**NOTICE
OSHTEMO CHARTER TOWNSHIP
PLANNING COMMISSION**

**THURSDAY, APRIL 29, 2021
6:00 P.M.**

Request: Site Plan and Special Use approval to construct a drive-thru

Request: Site Plan and Special Use approval to expand Emberly Acres II Condominium to the West including the extension of Glendora Lane and twenty (20) new condominium units.

C101

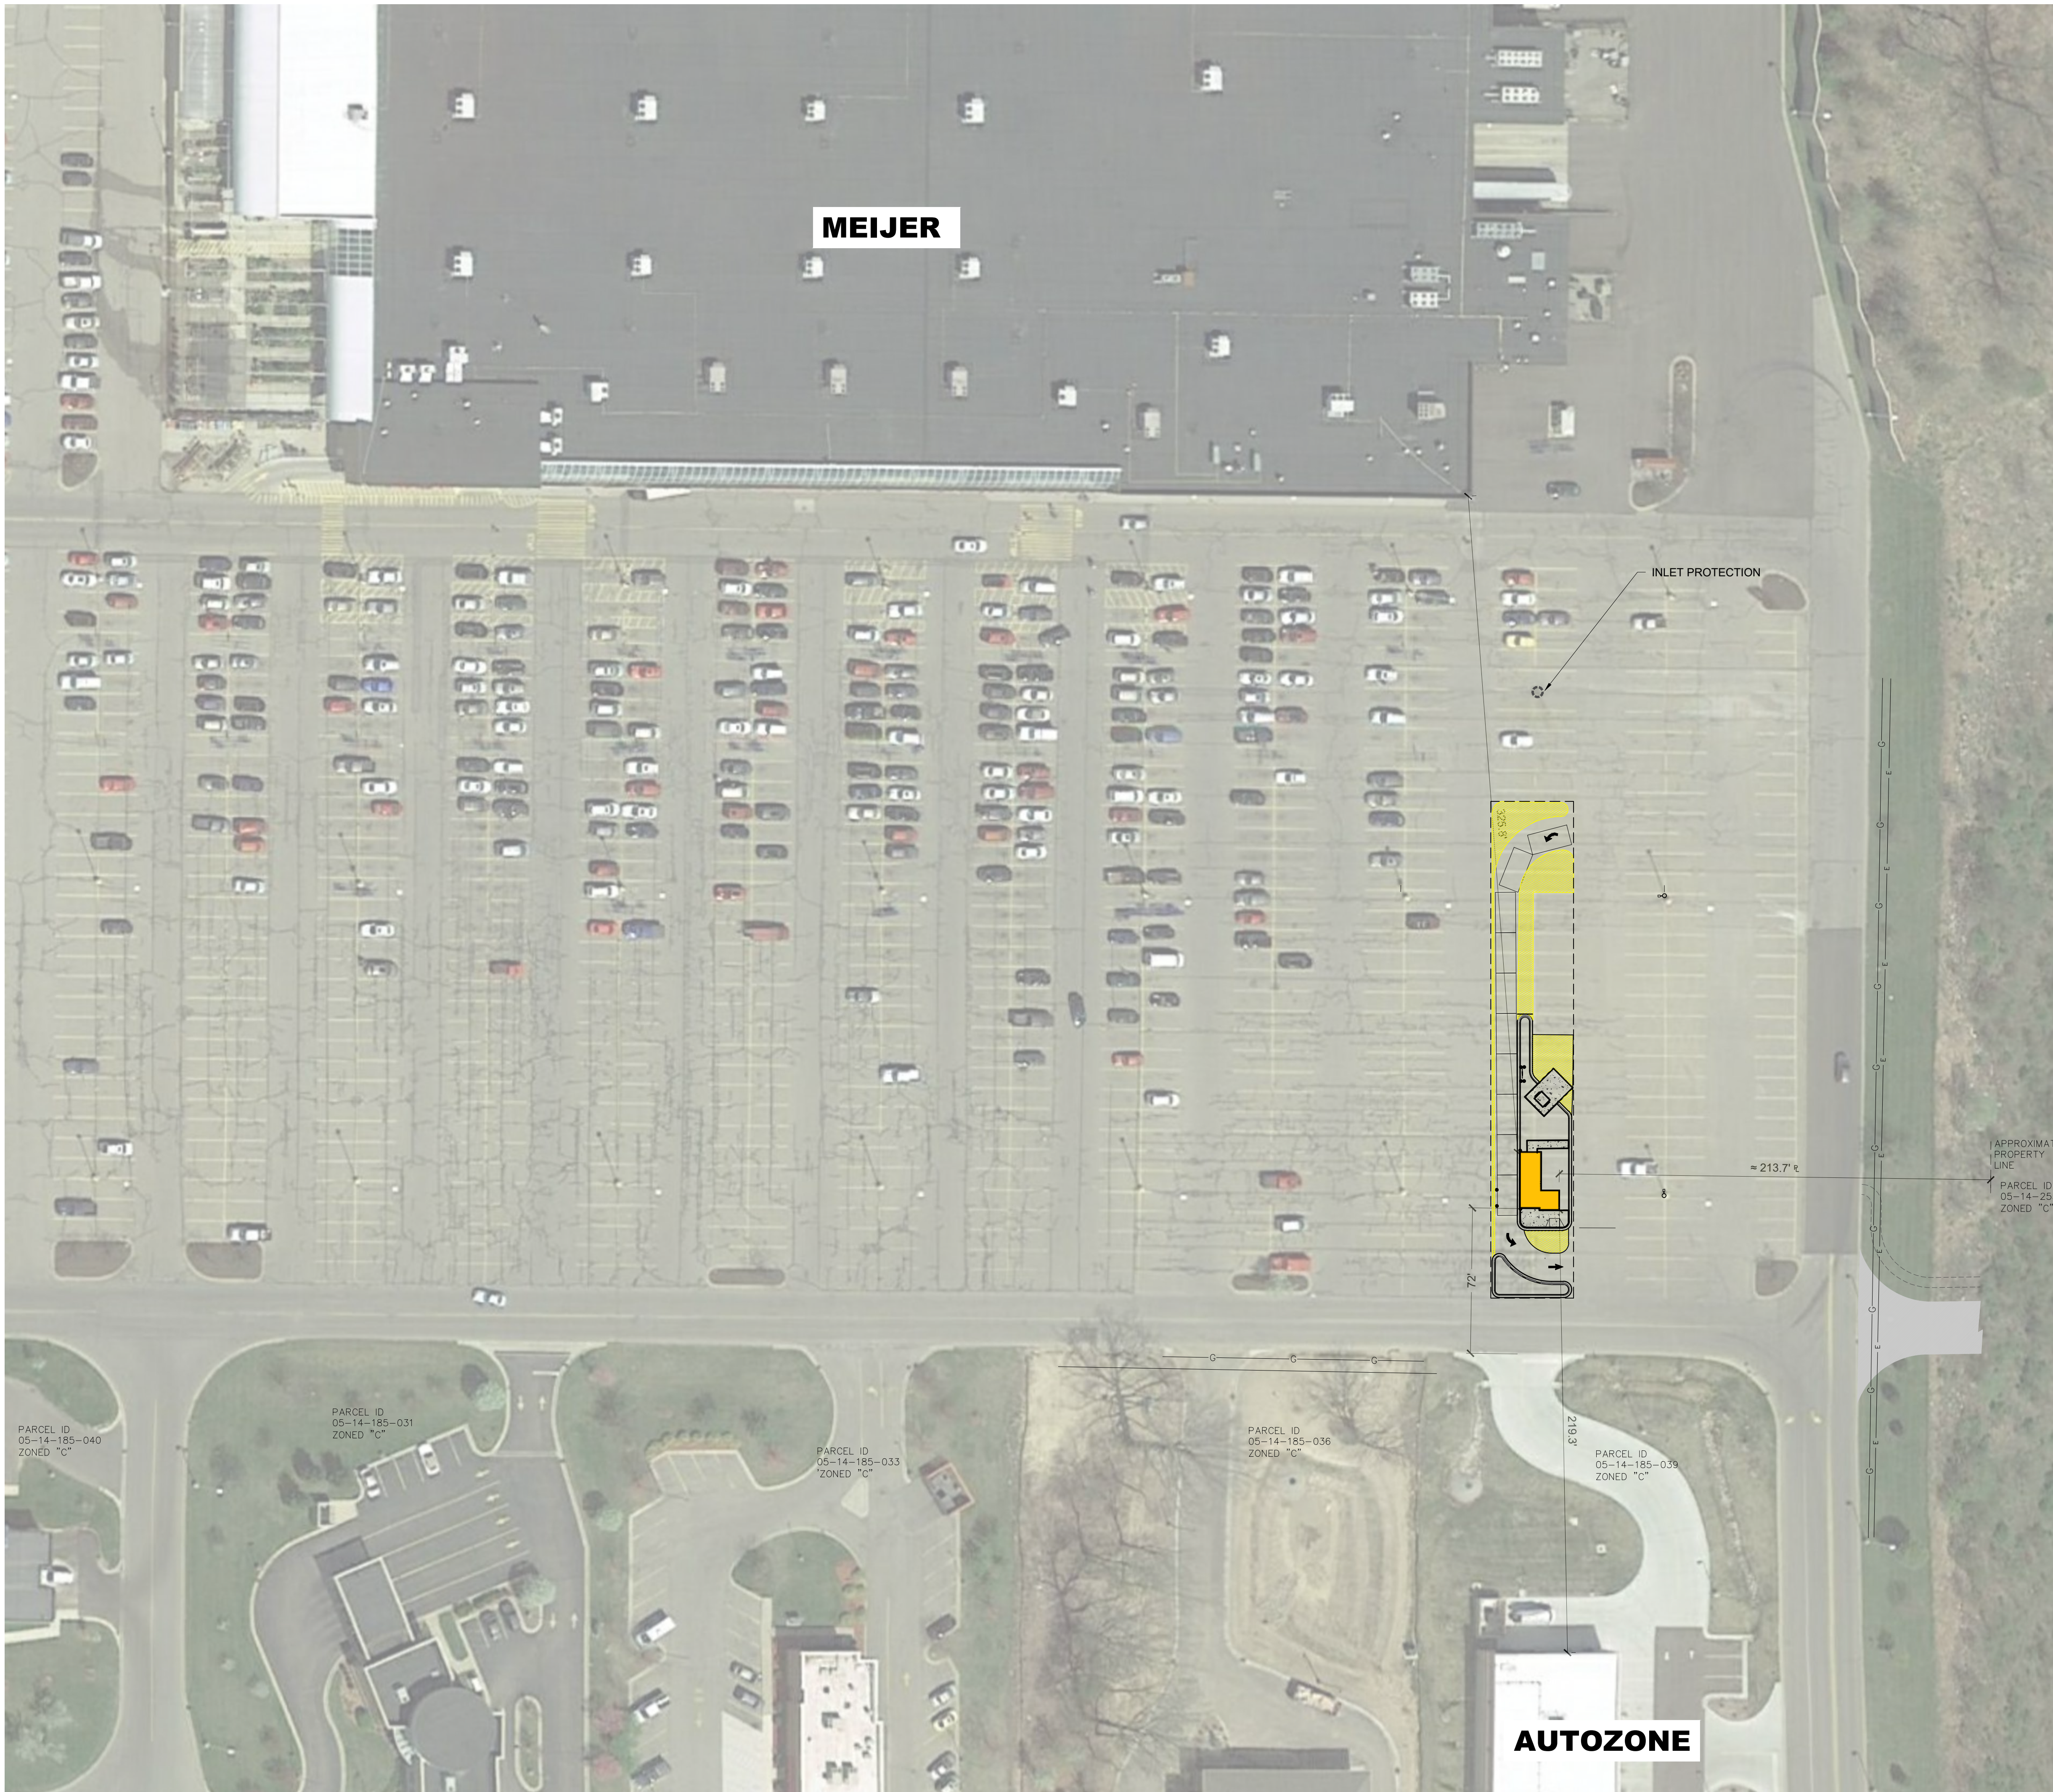
The proposed site plan includes the installation of one shade tree, and a mixture of new lawn area and 3" thick hardwood bark mulch. In general, the proposed landscaping plan meets the intent of the landscape ordinance and will improve the appearance of the site. All requirements appear to be met other than: 53.30 C. Site coverage – "Developed portions of the site not devoted to building floor area, parking, access ways or pedestrian use shall be appropriately landscaped with live plant material and maintained in a neat and orderly manner. Developed portions of the site shall mean the physical extension and/or construction of any man-made change or alteration to an improved or unimproved property". As noted under the Access and Circulation section of this report the proposed plan primarily uses striping to delineate the drive-thru aisle. Per section 53.30 C. these areas should be landscaped.

A photometric plan has been provided and meets code standards overall. However, LED wall light packs are proposed to be used to illuminate the building, see image to the right. Per section 54.60 of the Ordinance all luminaires are required to be cut-off fixtures. The proposed LED Wall light pack does not meet this requirement.

1. Approval of the requested landscaping deviation from 53.30 C. allowing the applicant to keep the striping shown on their plan.
2. An updated lighting plan, with cut off fixtures, shall be provided to staff for administrative review prior to building permit issuance.
3. An individual address shall be required for this lease area prior to building permit issuance.
